Keysight Truevolt 34460A 6 ½ Digit Multimeter
Keysight Truevolt 34461A 6 ½ Digit Multimeter
Keysight Truevolt 34465A 6 ½ Digit Multimeter
Keysight Truevolt 34470A 7 ½ Digit Multimeter

Firmware Update 3.02 Release Notes

(Previous release: 3.01)

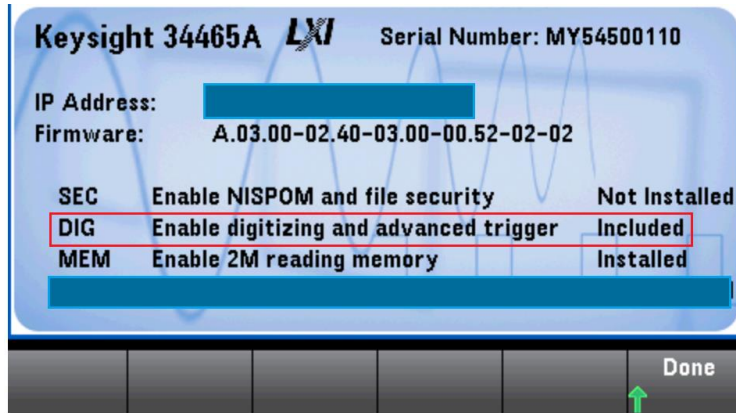
1. Beginning with Firmware revision 3.00, the digitizing and advanced triggering option (34465A-DIG/34470A-DIG/3446DIGU), is now standard. Instruments upgraded to 3.00 without the DIG option previously installed will show the option as 'Included' in the instrument's Help → About window:

Instruments upgraded to 3.00 with the DIG option previously installed will continue to show DIG as “Installed” in the Help → About window. There is no change in functionality. Note that all other 34465A/34470A options (SEC, MEM) must be purchased (as before) and installed using the license obtained when the certificate is redeemed.

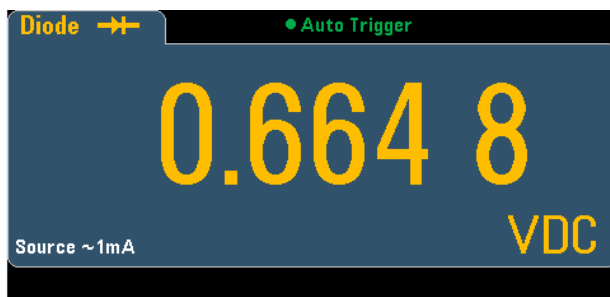
2. Adds a query which returns the DMM power on duration since the last power cycle. This is accessed from the front panel by pressing:

Shift → Utility → Test/Admin → Calibrate → Show Uptime

or by sending the command: SYSTem:UPTime?
